ADDENDUM IDAP REPORT

Property:	7 Patricia Street BELFIELD Lot: 40 DP: 35173 DA2021.300
Proposal:	Demolition of existing dwelling and construction of two (2) storey dwelling house with basement level.
Applicant:	Platform Five Design
Owner:	A Bechara
Date of lodgement:	17 November 2021
Notification period:	22 November 2021 to 6 December 2021
Submissions:	NIL
Assessment officer:	G I Choice
RECOMMENDATION OF OFFICER:	APPROVAL

Figure 4: Amended first floor plan

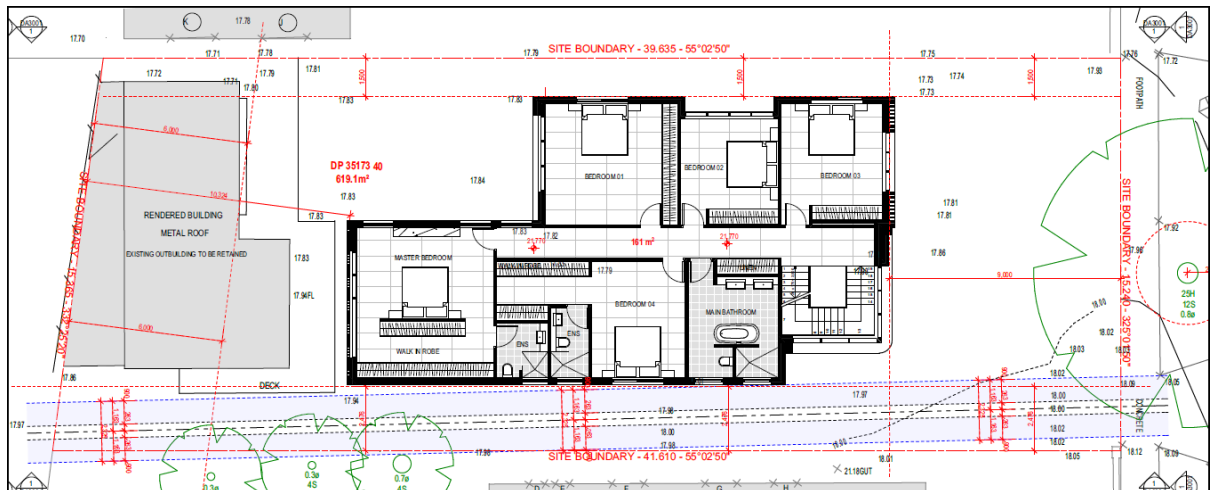
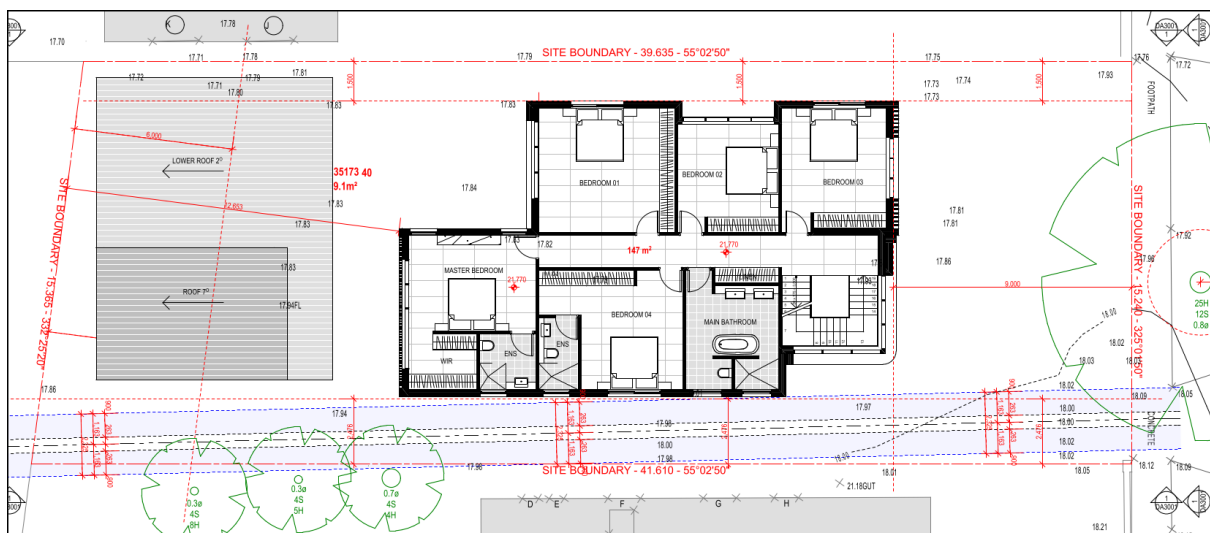
- The proposed cantilevered first floor section was not supported. The proposed dwelling design was to be amended so that no part of the first floor extends beyond the proposed alfresco area.

IDAP advised that the cantilevered first floor component, which was cantilevered above a substantial proportion of real landscaped area at ground level in the rear yard.

Officer comment: Amended plans show the removal of the cantilevered first floor area. The rear alfresco footprint has been increased and the Master Bedroom area has been reduced to sit wholly above the rear alfresco area. The assessment calculates a compliant landscaped area of 258.1m² or 41.6% of the 619.1m² total site area. This design change results in a slight reduction of landscaped area than previously proposed, however the issue of meaningful landscaped area within the rear yard has been generally resolved and is considered to address IDAP requirements.

Figure 6: Amended north elevation

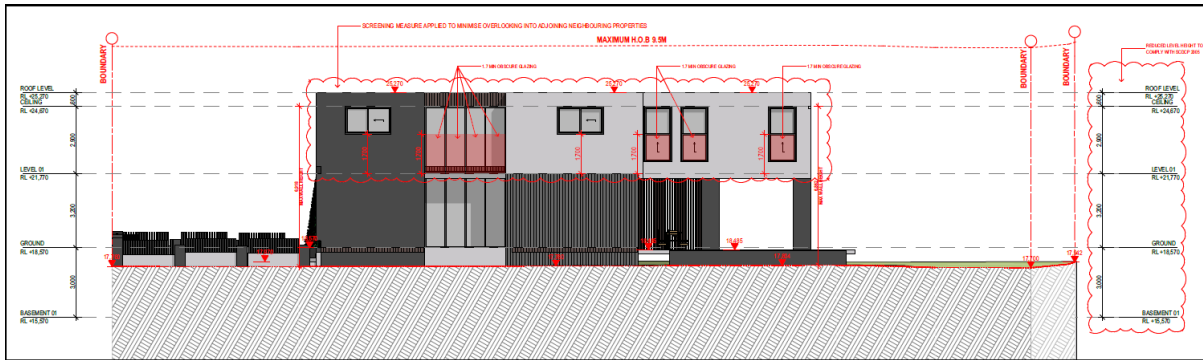
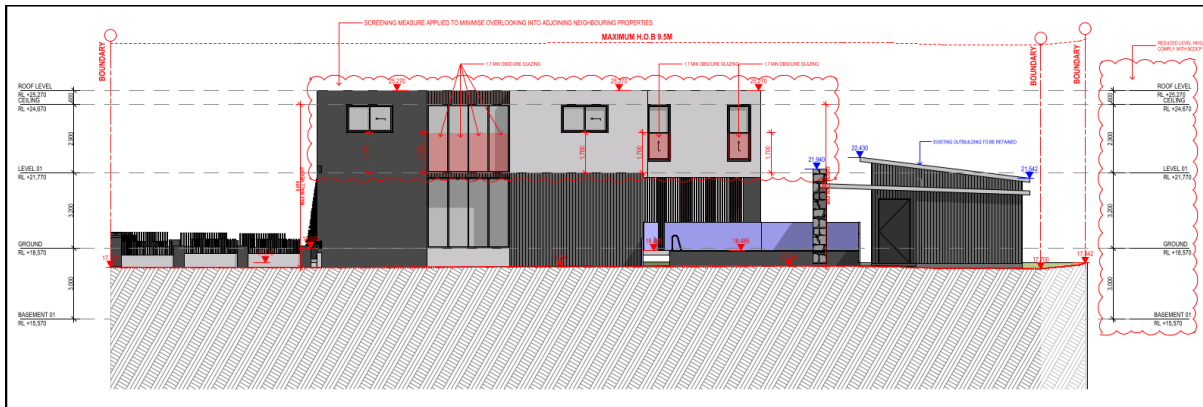
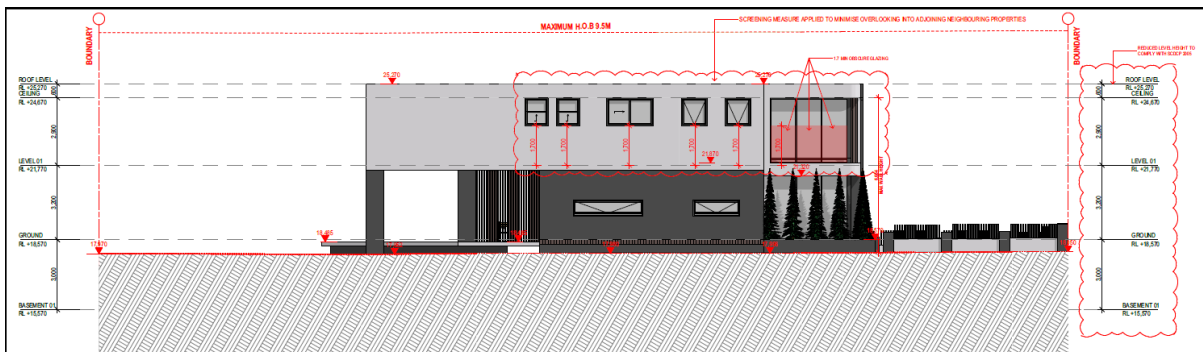
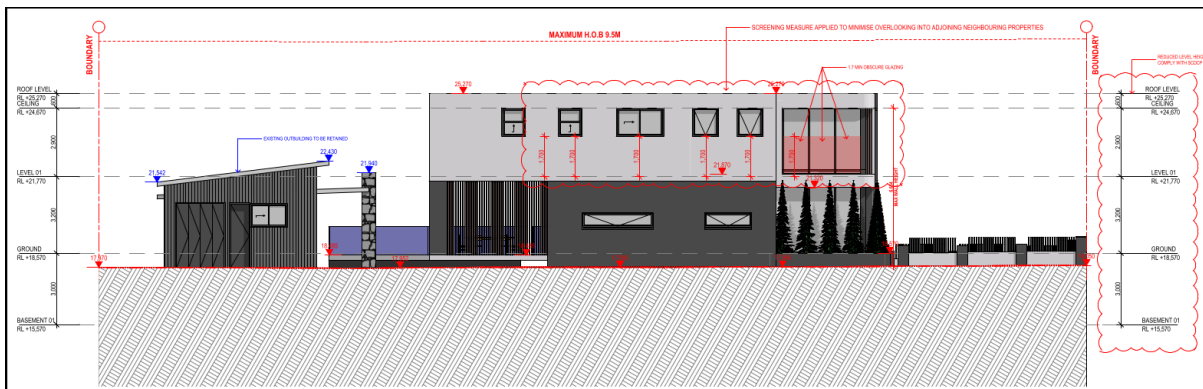
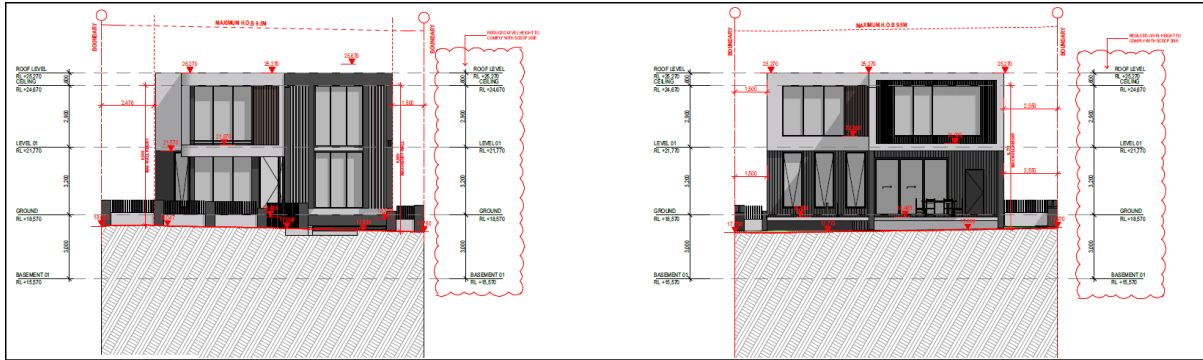
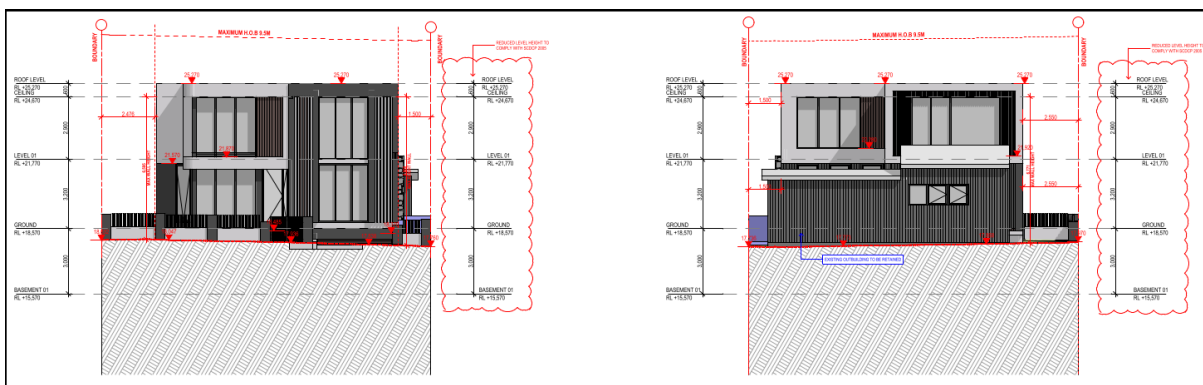
- Amended elevations plans were required to clearly show the location of the existing rear outbuilding

The outbuilding was omitted from all the elevations and sectional drawings, effectively misrepresenting what was to occur on site. Amended plans were required to show the extent of site coverage and massing from the front to rear of the site. As well as the internal floor plan of the outbuilding.

Officer comment: Amended plans show the location of the existing outbuilding. It is considered the proposal (as amended) presents a more accurate representation of the development and the removal of the cantilevered area has reduced visual impacts of bulk and massing. In this regard, the IDAP issue has been satisfactorily addressed.

Figure 12: Amended landscaped calculations

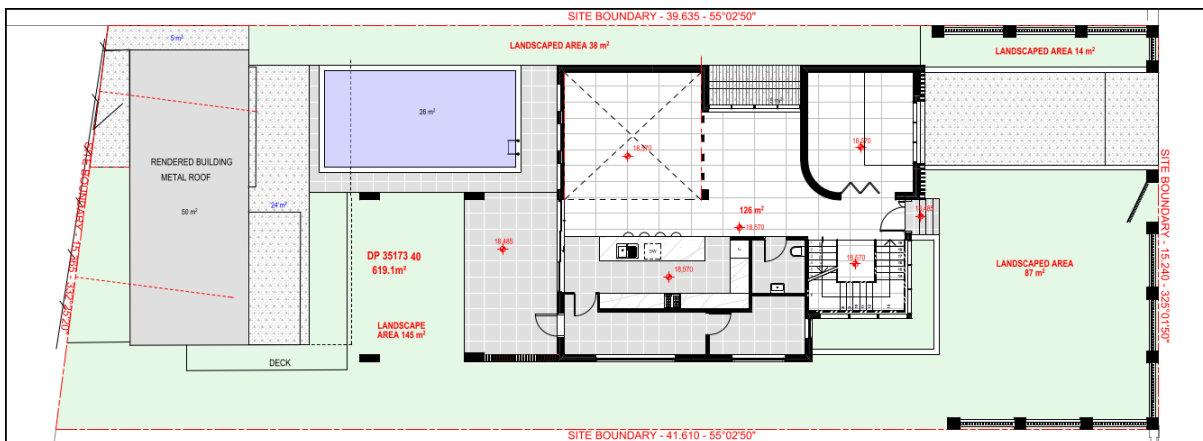
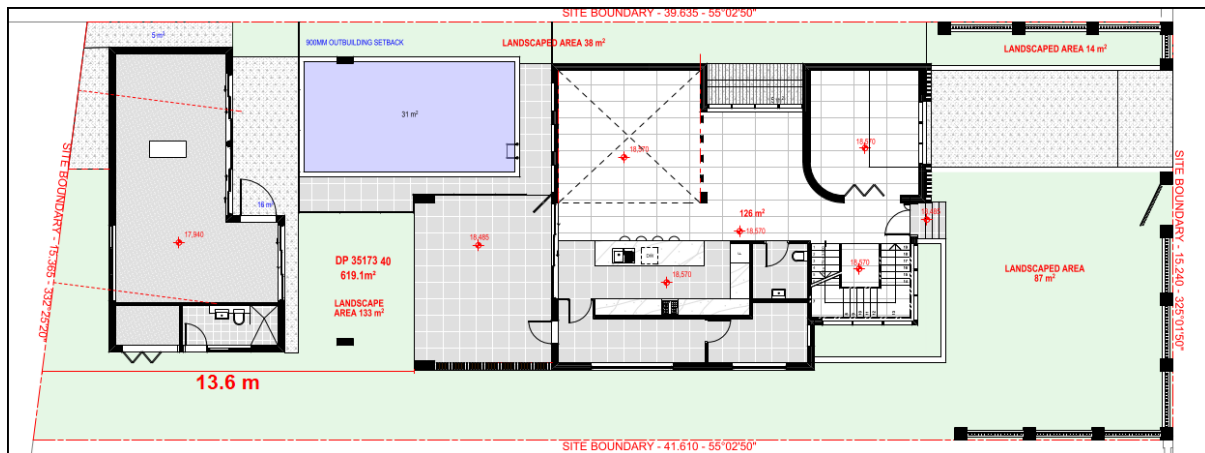
6 May 2022 The recommended approval of DA 2021/300 at 7 Patricia Street BELFIELD was deferred by Strathfield IDAP for further investigation of issues arising from the use of the existing outbuilding, insufficient landscaping and unnecessary bulk and massing basement floor plan, the provision of the alfresco area and elements of the dwelling design contributing to unnecessary bulk and overshadowing.
